Staff Report

To: Salt Lake City Planning Commission
From: David Stuenzi, Principal Planner
David.Stuenzi@slc.gov, 801-535-6135
Date: October 28, 2026
Re: PLNPCM2026-00591 & PLNPCM2026-00681, QuikTrip Gas Station

Conditional Use and Design Review

PROPERTY ADDRESS: 424 S Redwood Road

North elevation facing 400 S. Proposed employee entrance circled in blue.

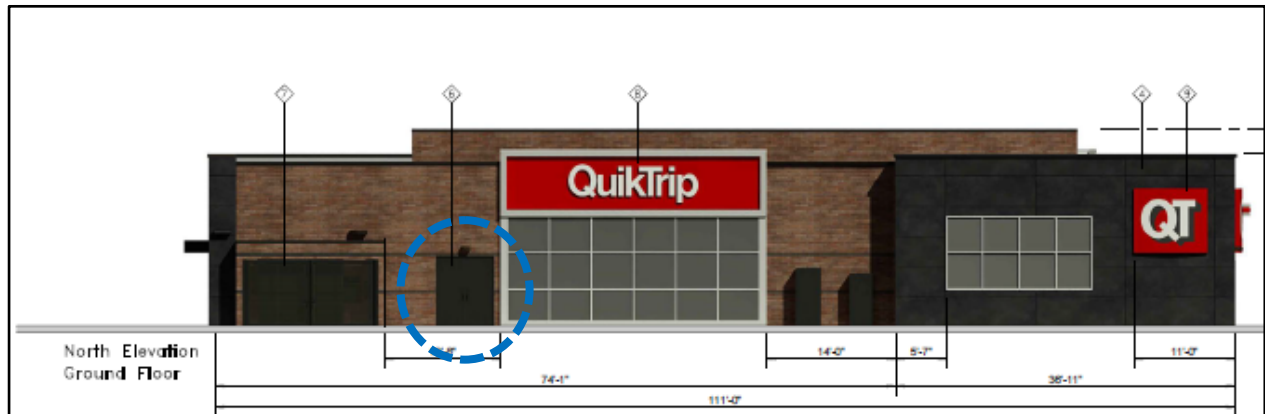
Although the applicant provides entrances on all four sides of the building, not all the entrances are available for customer use. The design standards require that all entrances provide customers with direct access to the use. The applicant requests reducing the number of customer entrances on the north side of the building to zero. The entrance on the north façade, which fronts 400 S, is an employee-only entrance and is shown in the image below:

To address the lack of a customer entrance on the north side, which faces 400 S, the applicant has provided a large architectural storefront feature with spandrel glazing, similar in appearance to the main customer vestibule on the south façade (pictured below).

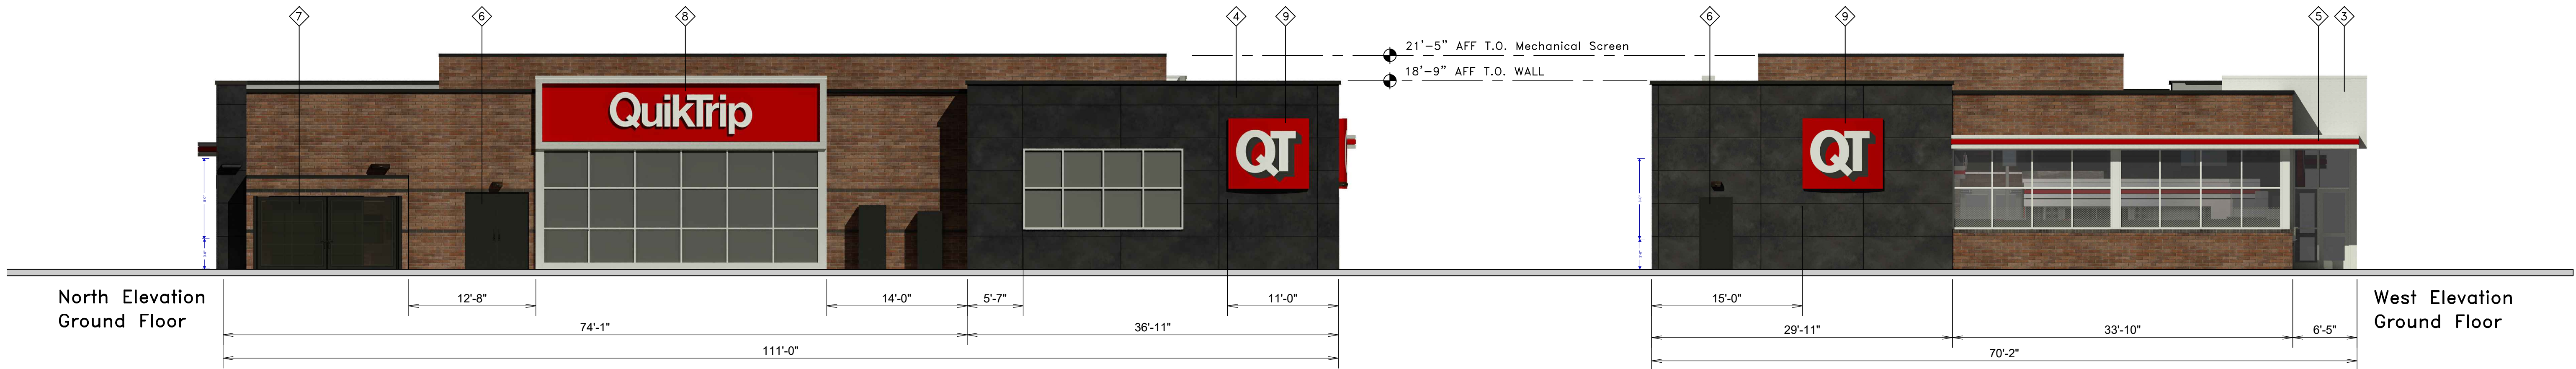
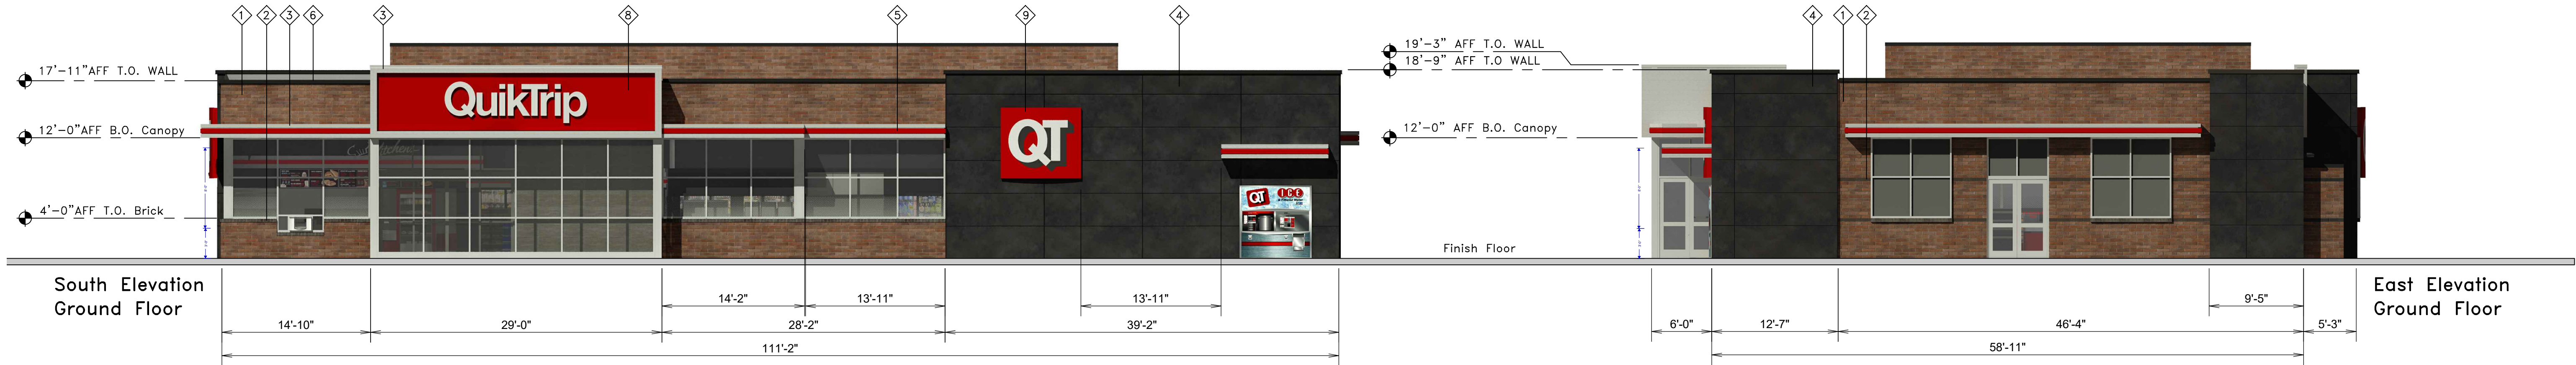
measured between 3' and 8' of the first floor: North side: 37% West side: 51% East side: 36% None of the three sides meet the minimum ground-floor glass requirements. The applicant is requesting modifications to the design standards through design review. The request is further discussed in Consideration 2.	
(C.2) Upper Floor Glass Minimum of 15% for each upper floor	There is no upper floor.	Not Applicable
(C.3) Reflective Glass: 0% of the ground floor or upper floor glass is permitted to be reflective.	No reflective glass is proposed.	Complies
